**Fuel Pipe – Rattle –
Install Pipe Clip**MODEL 1995 MY
XJ12 SedanVIN
720001 - 738089**ISSUE:**

ILLUSTRATION 1

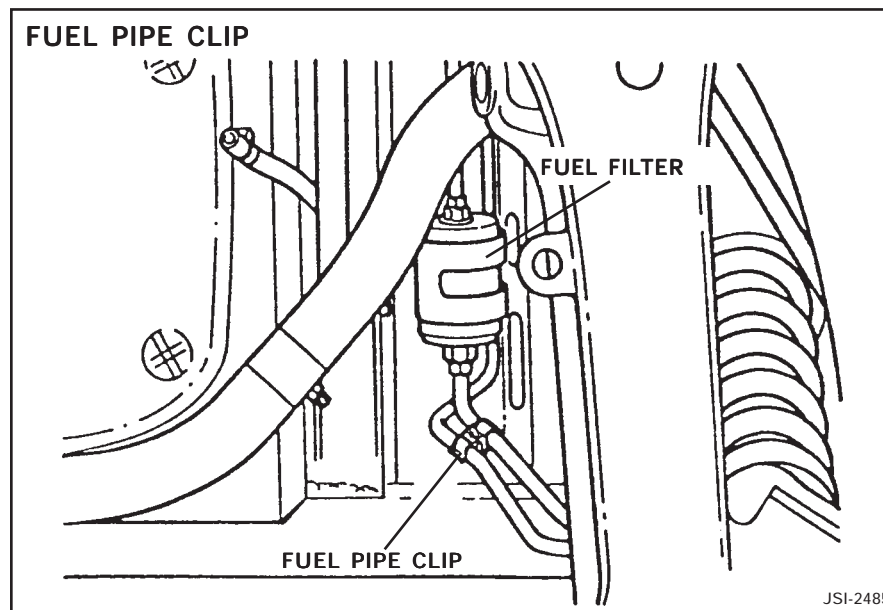
1995 MY Sedan Range vehicles within the VIN range above may experience a light rattle from the rear. The rattle occurs at idle with the vehicle stopped. A plastic fuel pipe clip was installed in production at VIN 738090 to stabilize the fuel pipes and prevent the possibility of a rattle.

1. Check the alignment of the fuel feed and return pipes near the fuel filter. The fuel pipes must not come into contact with any body member or adjacent pipes.
2. Install a plastic pipe clip (part number KDG 108104) between the fuel pipes as shown in Illustration 1.
